**CONVENTIONAL (NON-ENGINEERED)
 ON-SITE WASTEWATER TREATMENT SYSTEM (OWTS) DESIGN WORKSHEET
 (MUST BE COMPLETED FOR ALL CONVENTIONAL DESIGNS)**

Septic Permit Updated_V1.pdf Markup Summary

0036528
EL PASO COUNTY HEALTH DEPARTMENT
SAND SPRINGS, COLORADO
DISPOSAL INSPECTION FORM

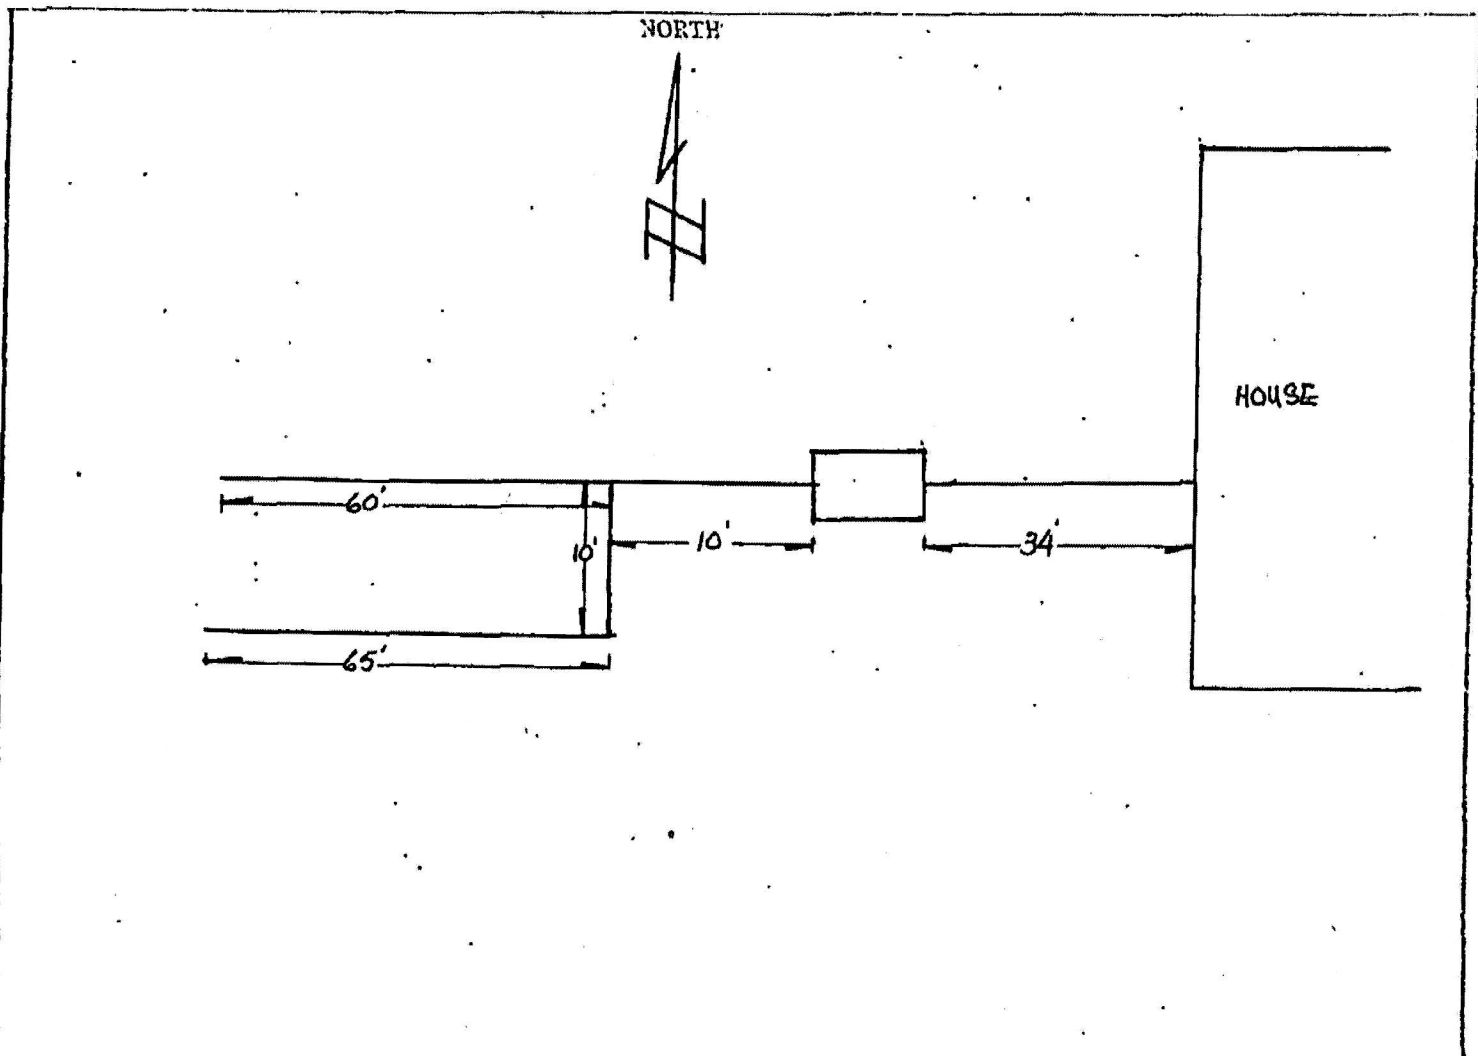
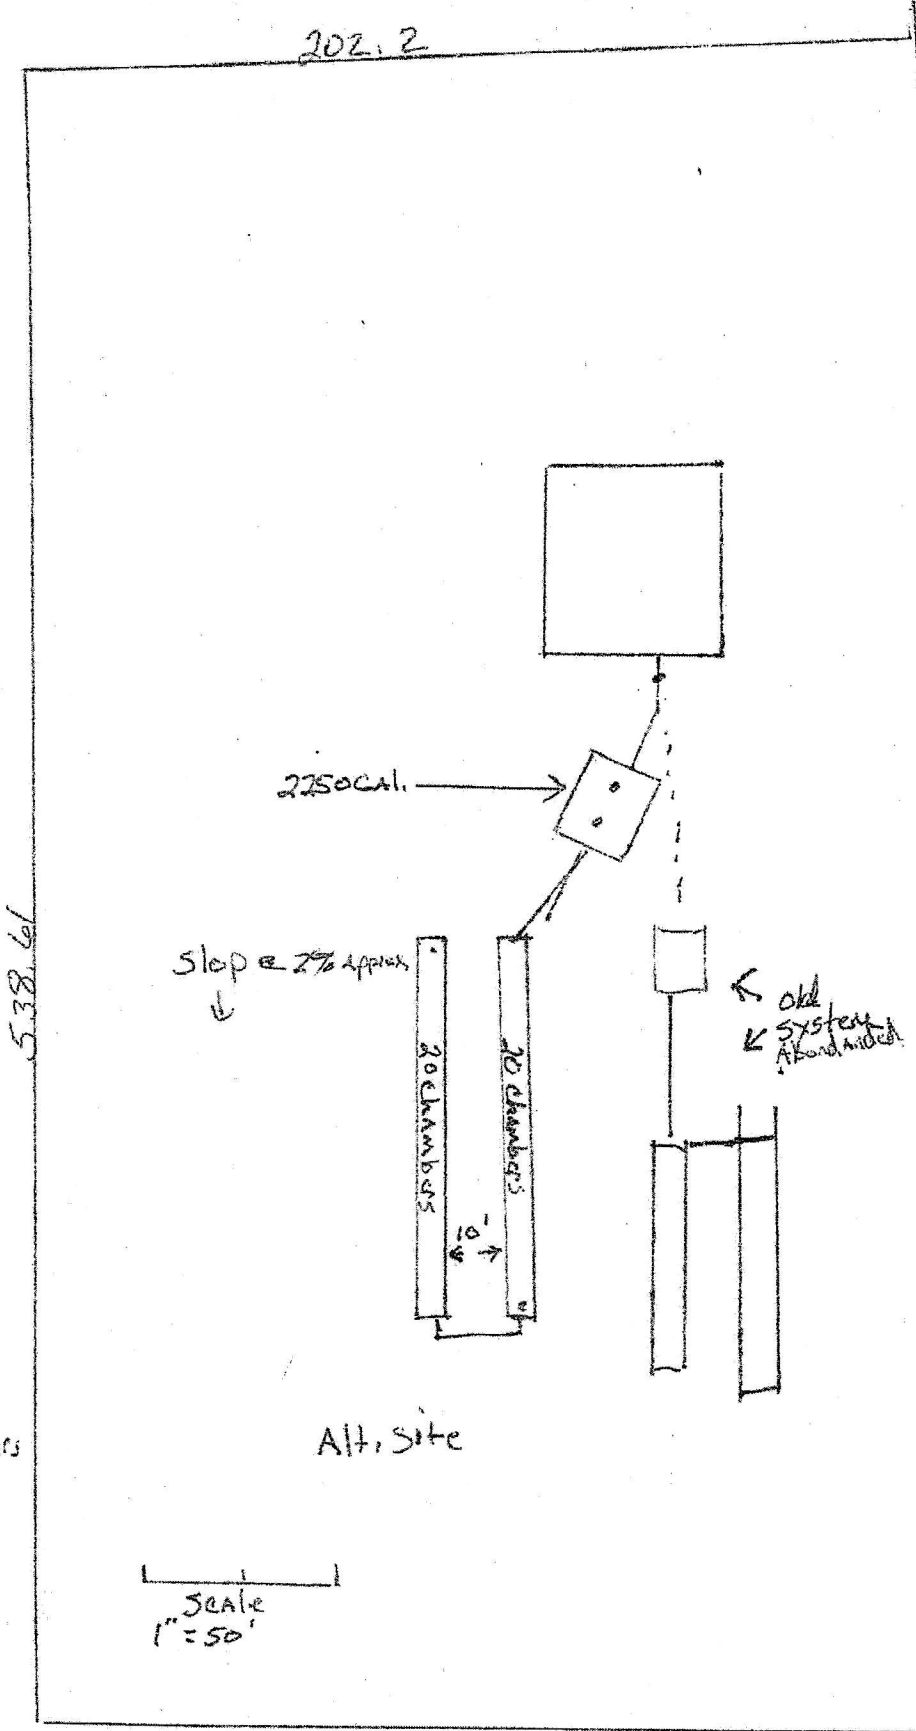
It appears that this is the original septic permit from '82 for the existing 6-bedroom house. This will serve as a placeholder for now if an updated septic permit is not attainable at this stage/prior to this special use approval. Please note, however, that an updated septic permit will be required either prior to approval of this project, or prior to building permit issuance as a conditional of approval for this project.
